OPTIONAL SERVICE BULLETIN NO. DAC1-27-04 REV. 1
SUPERSEDES DAC1-27-04 REV. 0

This service bulletin allows the installation of the Diamond Aircraft flap control module unit and microswitch tray.

Diamond Aircraft Industries
OPTIONAL SERVICE BULLETIN
Model DA 20-C1

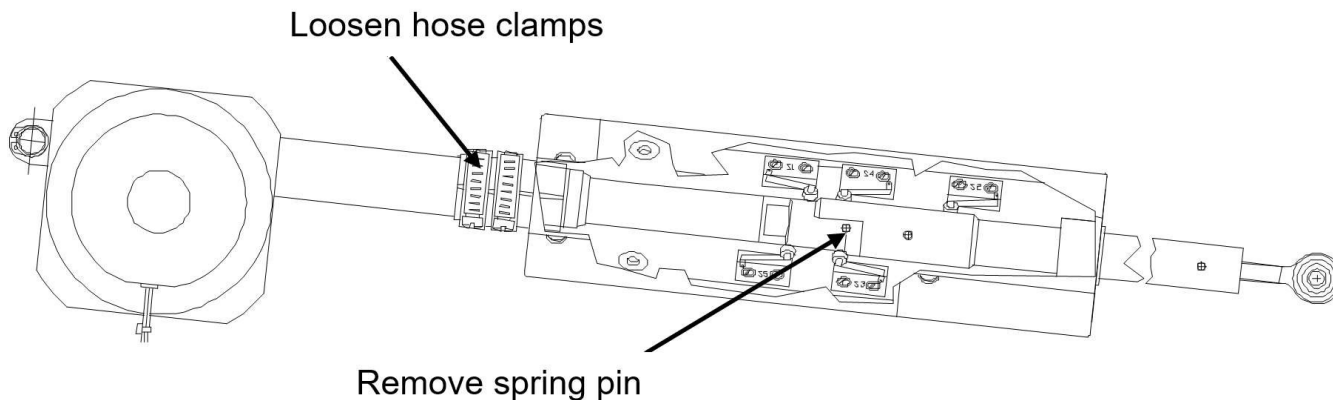
1. Pull the battery circuit breaker located on the right side of the instrument panel.
2. Disconnect the aircraft battery as per AMM Chapter 24-31-00.
3. Remove the instrument panel cover as per AMM Chapter 25-10-00.
4. Remove the flap controller from the instrument panel. The controller on non-G500 equipped aircraft is shown below on the left; the controller on G500 equipped aircraft is shown on the right.

5. Plug the flap controller connector on the instrument panel harness into the Diamond Aircraft flap controller (P/N 22-2753-20-00SB), and install it into the same location as the previous controller. Use the supplied hardware.

NOTE: serial numbers C0002 through C0144 may have a circular connector on the previously installed controller. If so, install the retrofit harness (P/N 22-3914-10-00).

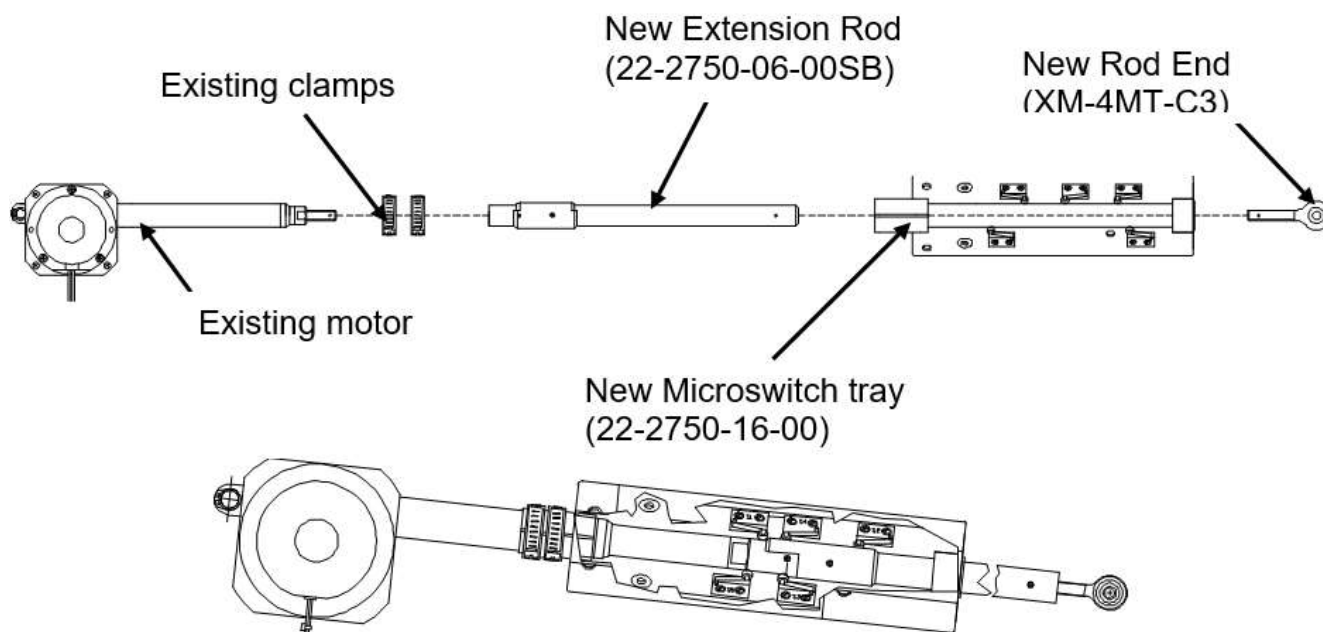
6. Remove the flap actuator as per AMM Chapter 27-50-00. If the optional flap actuator assembly is ordered, proceed to step 14.
7. Remove the spring pin shown below and loosen the hose clamps. Remove the microswitch tray and rod assembly from the flap motor.

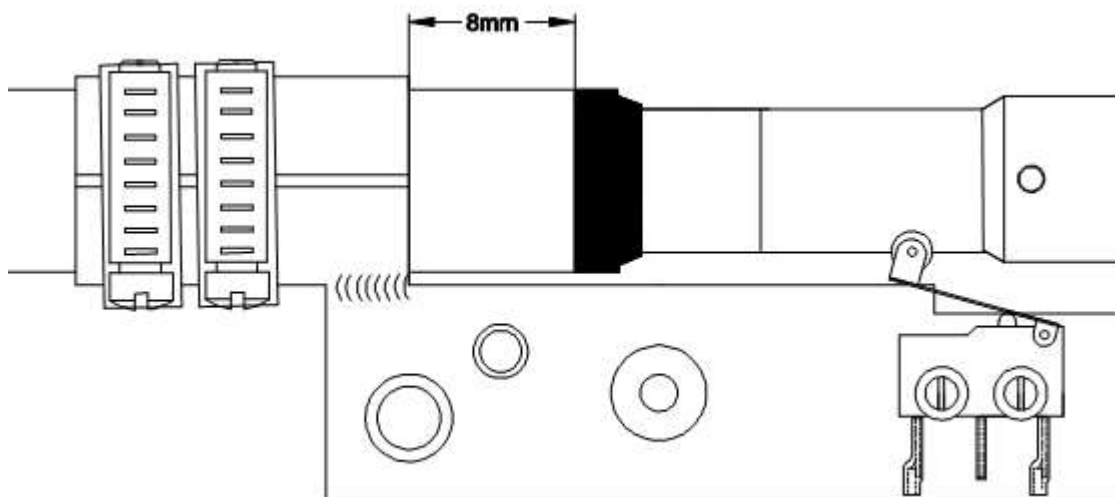
8. Assemble the flap actuator as shown below. Use the new supplied parts. Install and secure the hardware with Loctite 222.

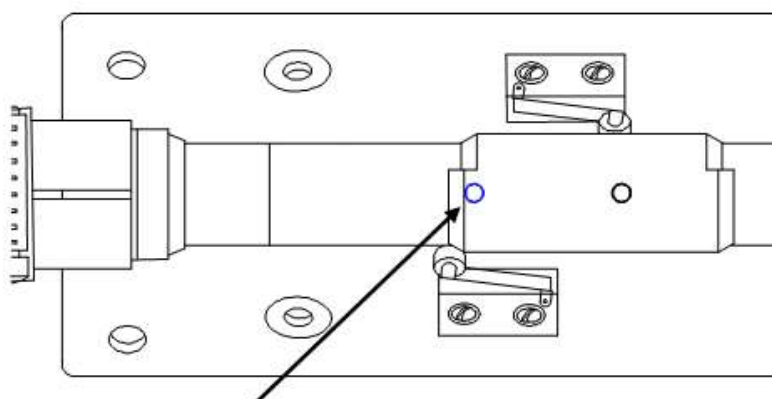
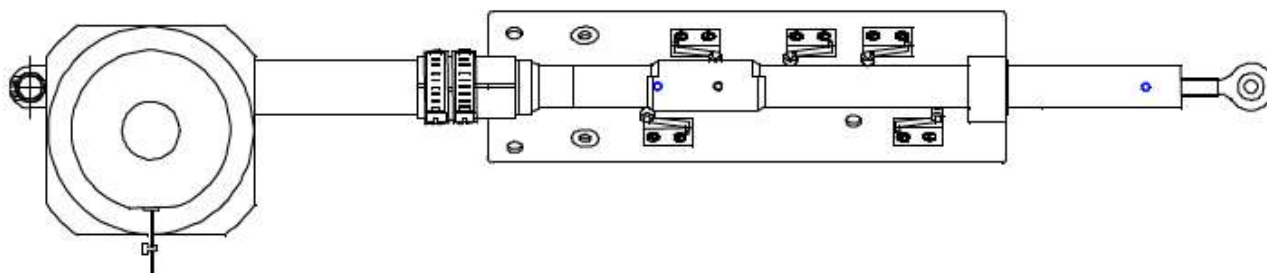
10. Install the extension rod onto the motor end. Align the pilot hole in the extension rod with the existing hole in the motor end. Verify that the extension rod has reached proper engagement. Open the pilot hole on the extension rod with a 1/8" drill bit as shown below.

NOTE: take care not to bend the switch plates at the weld joints when drilling.

Drill through motor end
with 1/8" drill bit.

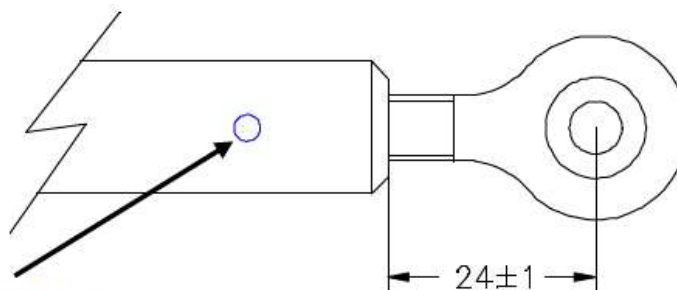
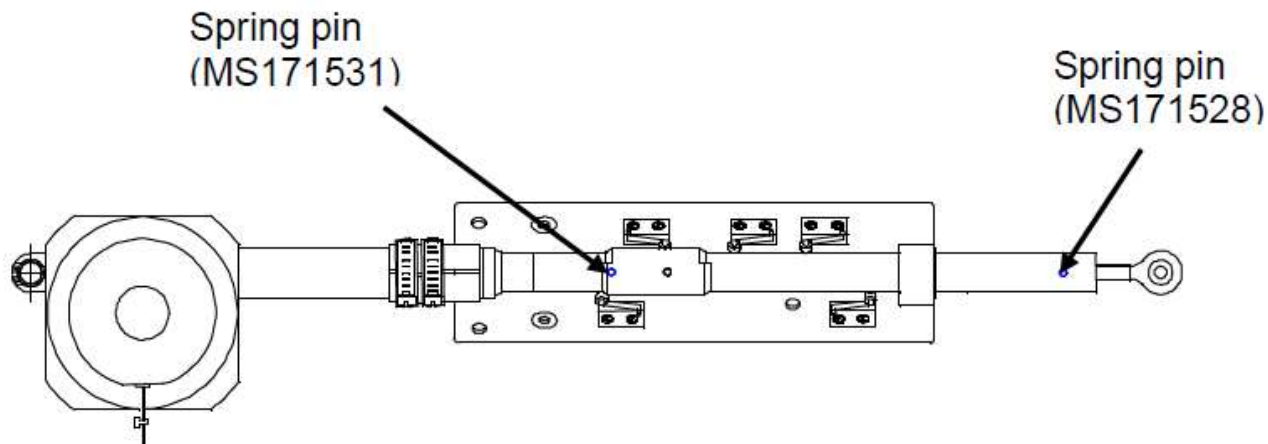
11. Position the rod end as shown below, and drill through the extension rod hole and rod end with a 1/8" drill bit.

NOTE: take care not to bend the switch plates at the weld joints when drilling.

Drill through rod end
with 1/8" drill bit.

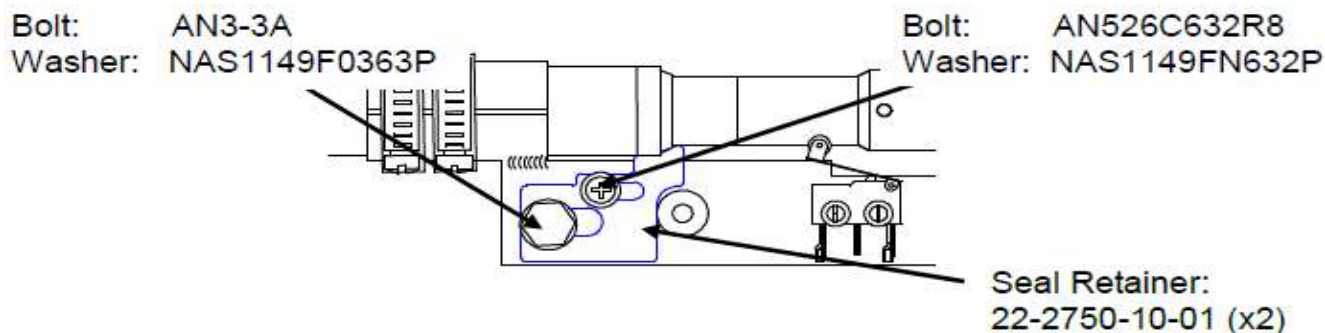
12. Install the spring pins into the extension rod as shown below.

NOTE: take care not to bend the switch plates at the weld joints when drilling.
